Access Compliance Report

Public Rights-of-Way

Intersection ID: 14681	Main Street: FAIRWOOD_AV	Cross Street: GRIFFITH_ST	Location:	E
ADA ID: 6CE8F68EBB92	Ramp Type: Perp	Initial Pass/Fail: Fail	Overall Compliance: No	Severity Score: 22.5
Codes/Mitigation Info/Possible Solution		Field Measurements/Component Compliance

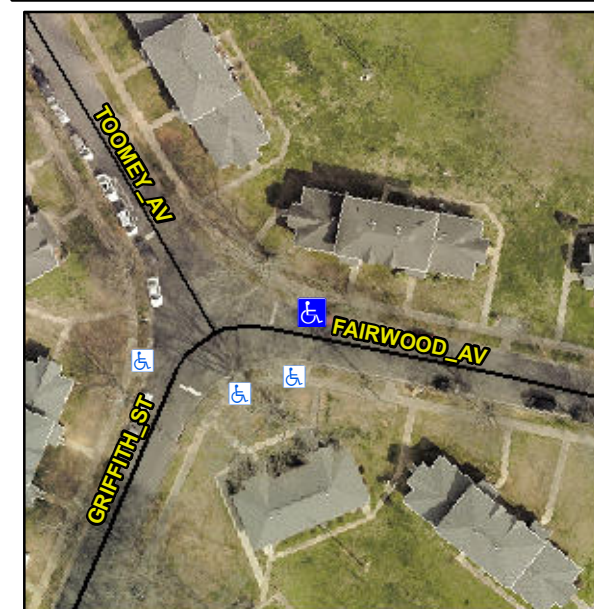
R304.5.1, R304.2.2, R304.5.3

Compliance	Description	Data	Compliance	Description	Data
N/A	Ramp Length (in)	61.5	No	Ramp Slope (%)	10.5
No	Ramp Width (in)	46.0	No	Ramp XSlope (%)	2.4
N/A	Flare Type LT	N/A	N/A	Flare Type RT	N/A
N/A	Flare Slope LT (%)	N/A	N/A	Flare Slope RT (%)	N/A
N/A	Flare Traversable LT?	N/A	N/A	Flare Traversable RT?	N/A
N/A	Landing Length (in)	N/A	N/A	DWS Provided?	N/A
N/A	Landing Width (in)	N/A	N/A	DWS Contrast?	N/A
N/A	Landing Slope (%)	N/A	N/A	DWS Length (in)	N/A
N/A	Landing X Slope (%)	N/A	N/A	DWS Full Width?	N/A
N/A	Landing Curb? (Y/N)	N/A	N/A	DWS Offset (in)	N/A
N/A	Shared Landing?	N/A			
N/A	Gutter Ponding?	N/A	N/A	Gutter Slope (%)	N/A
N/A	Gutter Lip Ht (in)	N/A	N/A	Gutter X Slope (%)	N/A
N/A	Painted X Walk1?	No	N/A	Painted X Walk2?	N/A
	X Walk 1 Direction	To SW		X Walk 2 Direction	N/A
N/A	X Walk 1 Width (in)	N/A	N/A	X Walk 2 Width (in)	N/A
	X Walk 1 Slope (%)	3.1		X Walk 2 Slope (%)	N/A
	X Walk 1 X Slope (%)	2.2		X Walk 2 X Slope (%)	N/A

Remove & Replace Entire Ramp.
